Access Compliance Report Public Rights-of-Way (Pedestrian Signals)

Main Street: **FOOTHILL BLVD** Cross Street: **NEWPORT AVE** Location: **NE**

ADA ID: **SGAT211018092322** Signal Type: **One Push Button-Non APS** Overall Compliance: **No** Severity Scores: **BTN 1: 35** **BTN 2: N/A** **No BTN: N/A**

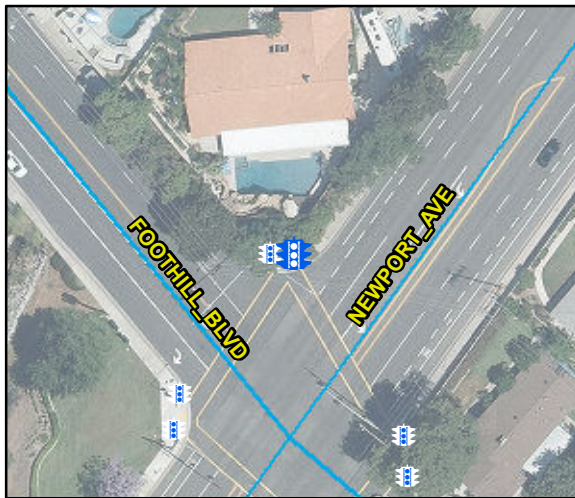
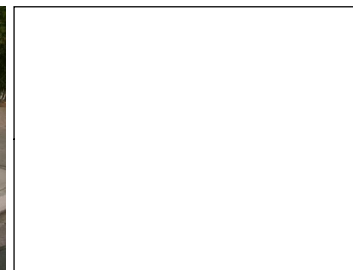
OC Std/PROW: R404.1, MUTCD 4e.08

Possible Solutions: Replace Signal Push Button With APS Button. Provide Clear Space.
